## ADDENDUM

Campus HVAC System Upgrade  
Freemont Magnet Elementary School  
Bakersfield City School District  
566-0018  
DSA #03-122640

Subject: Addendum #002

ADD-002.01

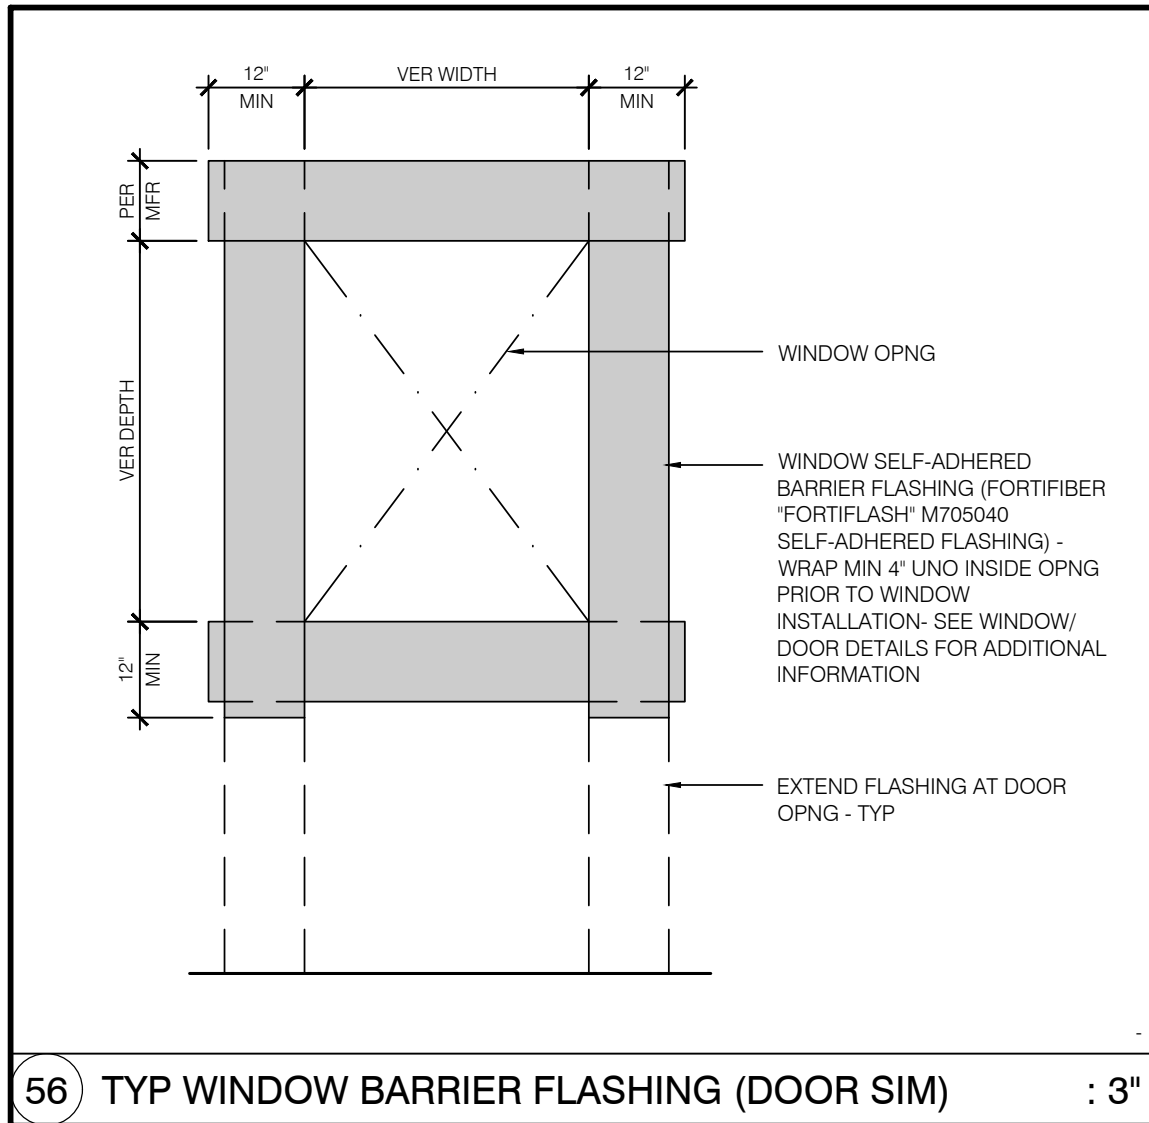
- 2.7.2 Refer to Partial Site Plan C:
- 2.7.3 Revise Detail 32 as indicated on attached Detail **ADD-002.01** as denoted by clouded areas with Delta "2".

**ADD-002.02**

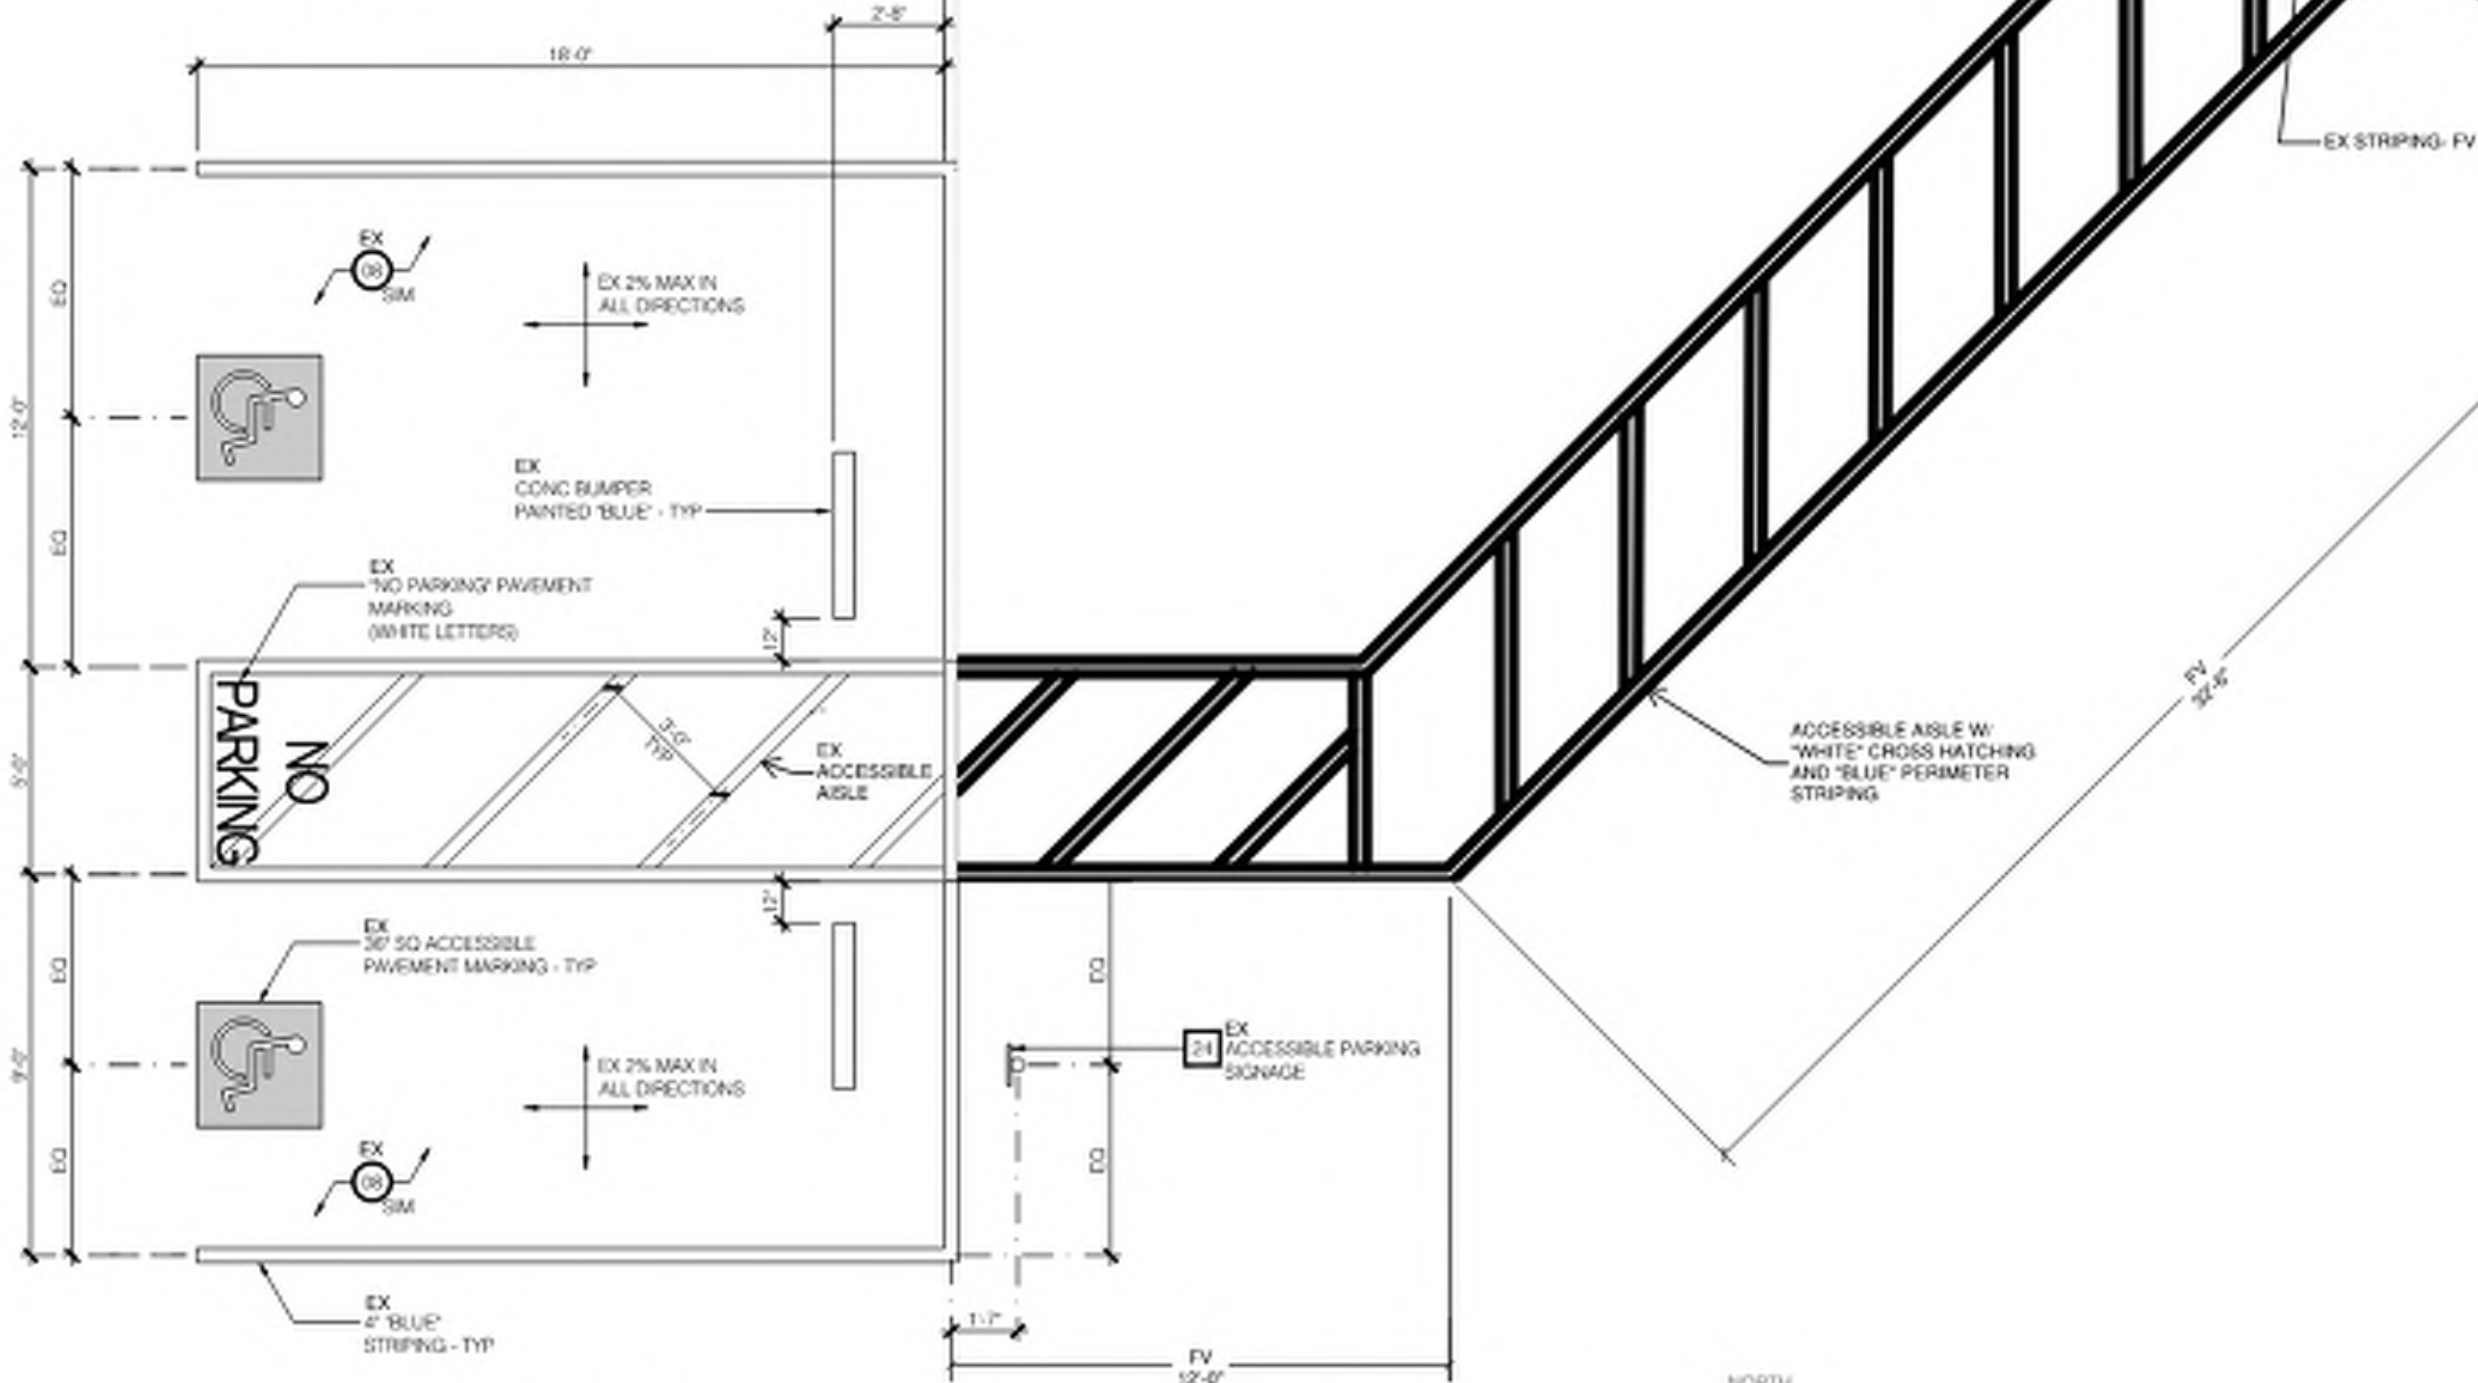
- 2.7.5 Refer to Partial Site Plan E:
  - 2.7.5.1 Revise as indicated on attached Detail **ADD-002.02** as denoted by clouded areas with Delta "2".
- 2.7.6 Refer to Partial Site Plan F:

ADD-002.04

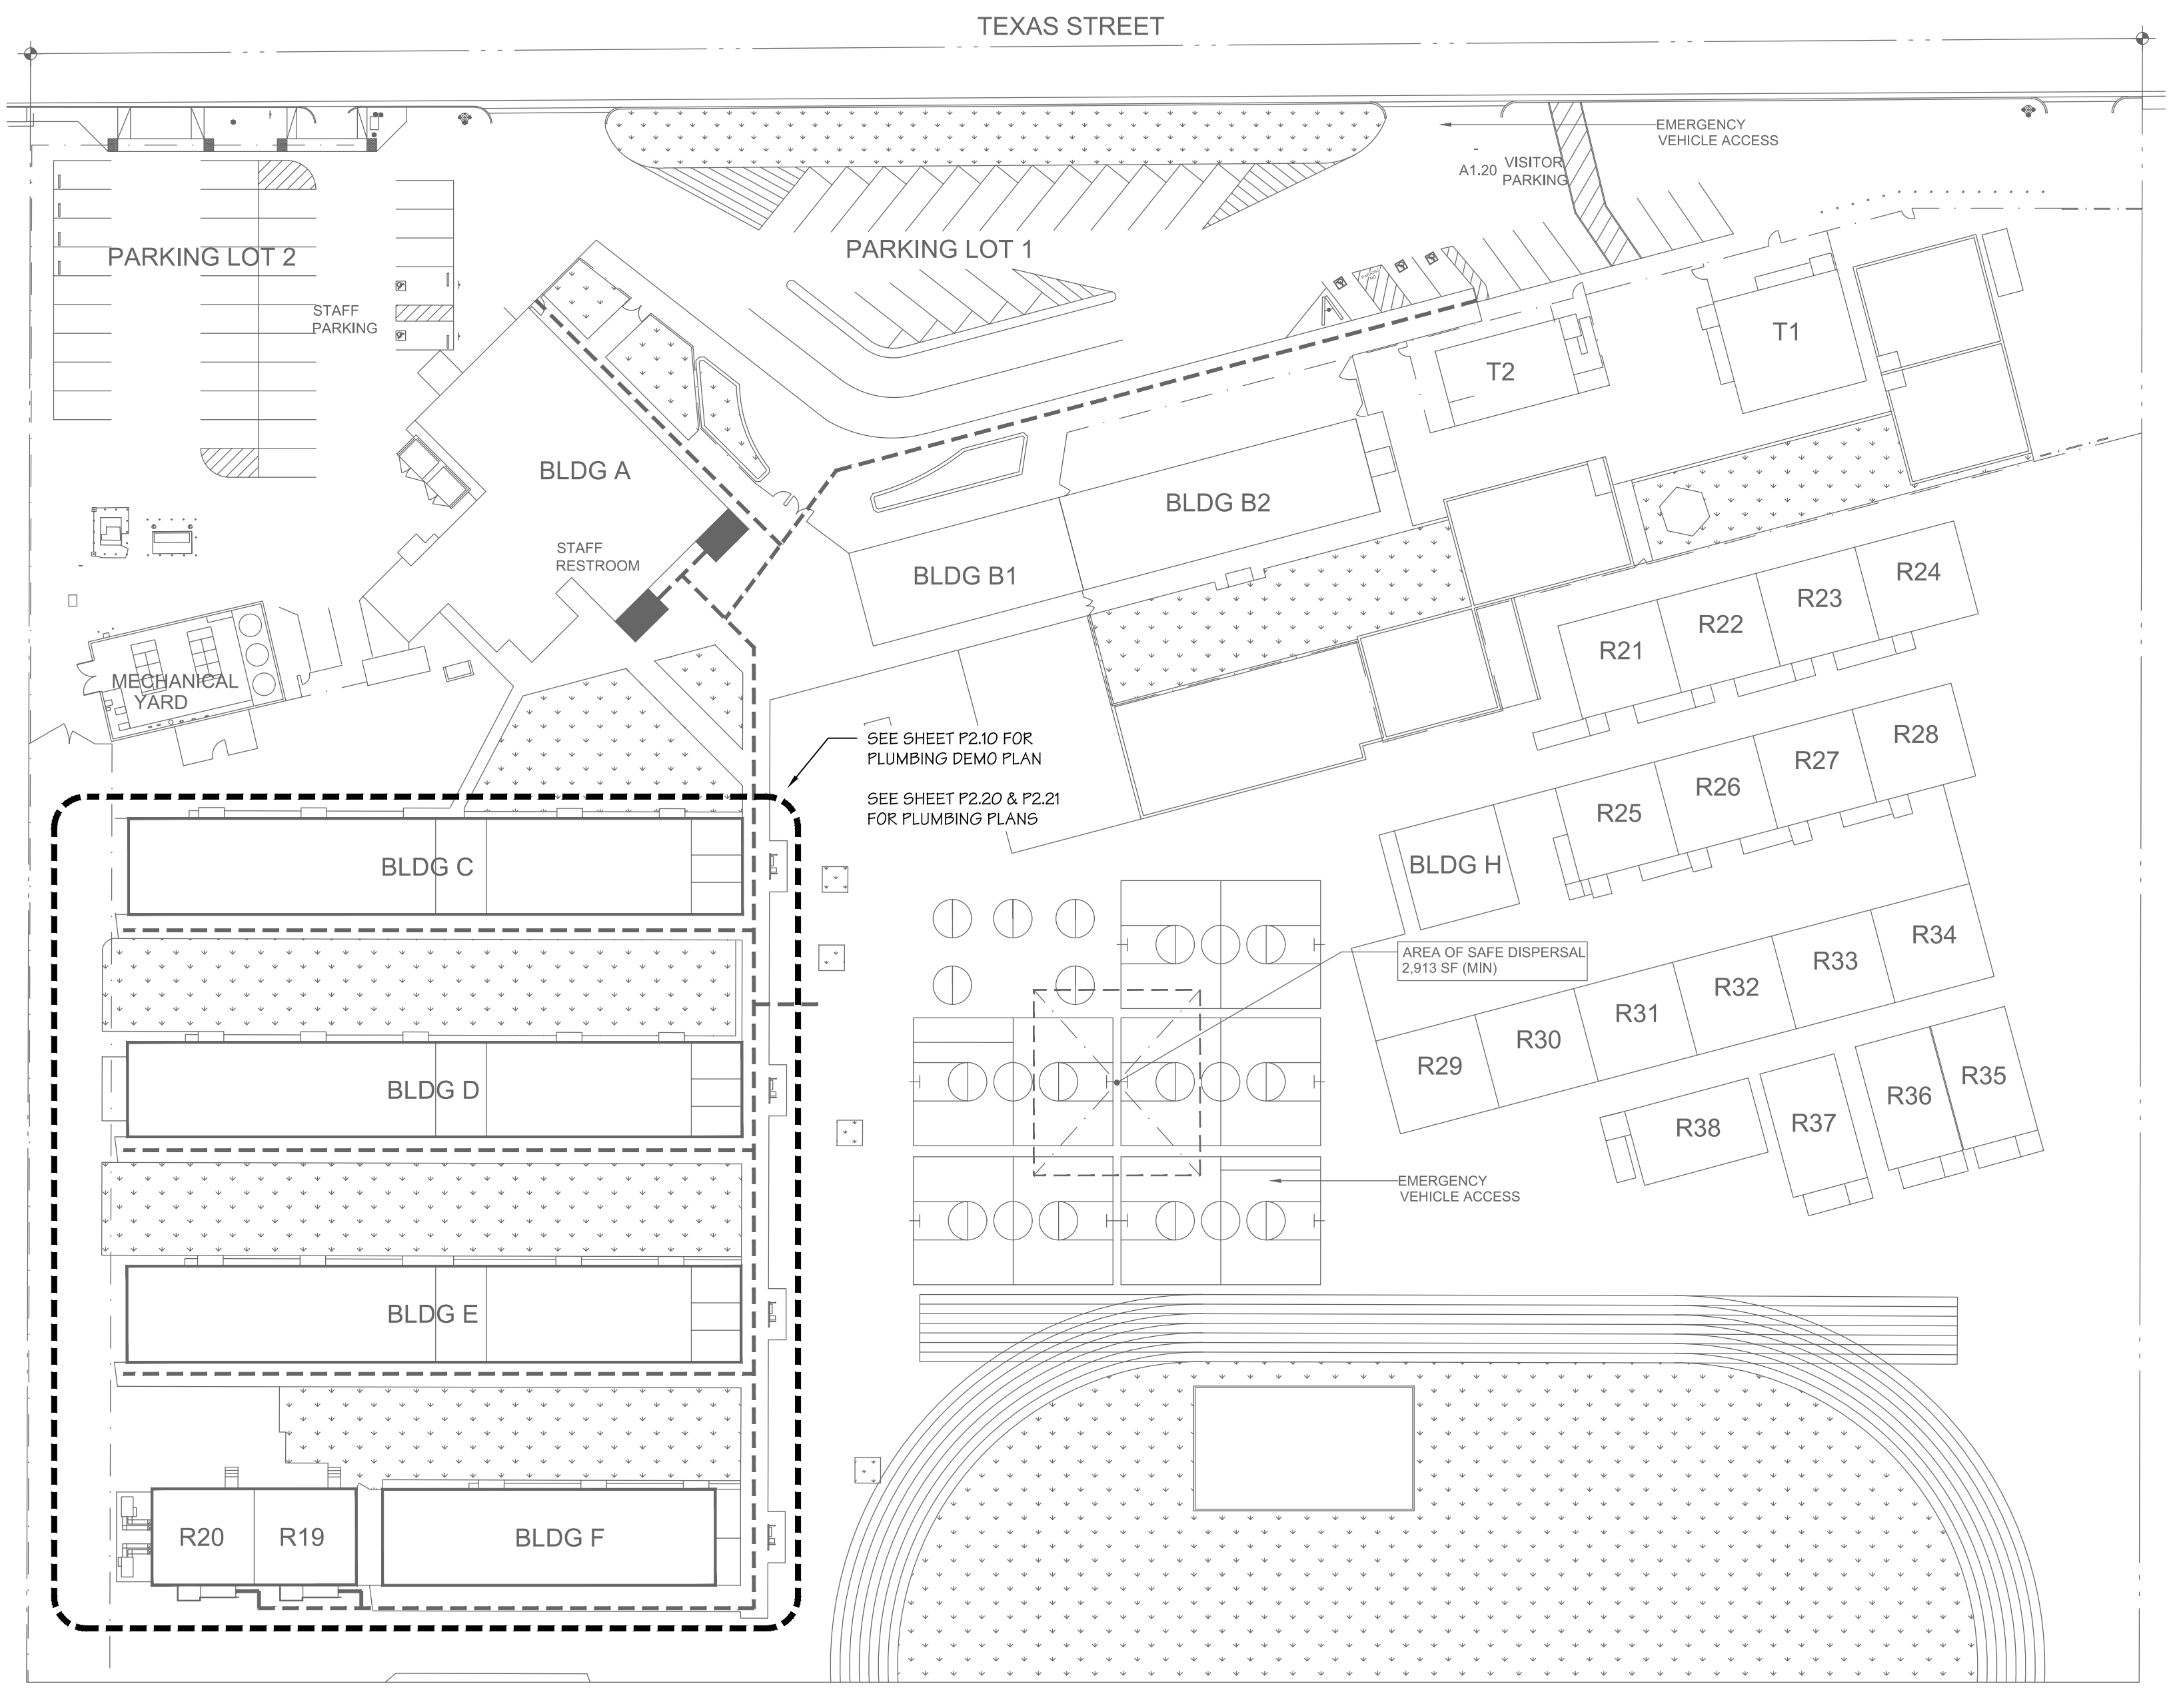
- 2.12 Refer to Sheet S3.02:**
  - 2.12.1 Replace Detail 3 with attached Drawing **ADD-002.04** as denoted by clouded areas with Delta "2".
- 2.13 Refer to Sheet P1.00:**
